John Stacey

Further Submission dated 04/08/2026

My Responses to **REP7-481** Document: 8.4.16 Applicant's Comments on any Further Information or Submissions Received by Deadline 6

Image 4.9 Vegetation clearance requirements for standard lattice pylons

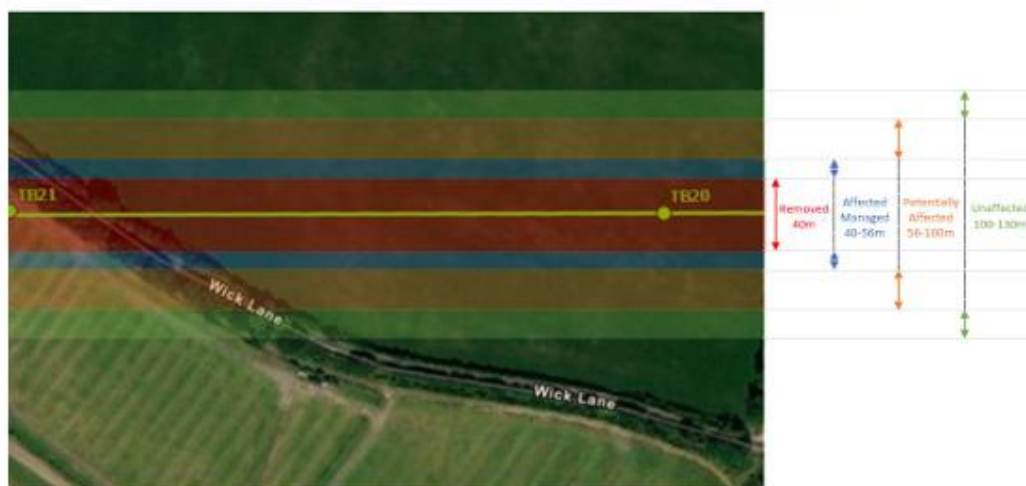
Looking at the REP7-056 Document: 2.16 Trees and Hedgerows to be Removed and or Managed Plans - Section E - Clean Version

The plans clearly show the trees that are Removed, Affected managed, Potentially affected.

The trees removed are along the centre are the proposed distance from this line.

What are the plans if the centre is moved?

If the centre line is moved to one side will the trees that have been planned to be removed now potentially remain.

In practice will trees to be removed be assessed after the exact pylon position is established?
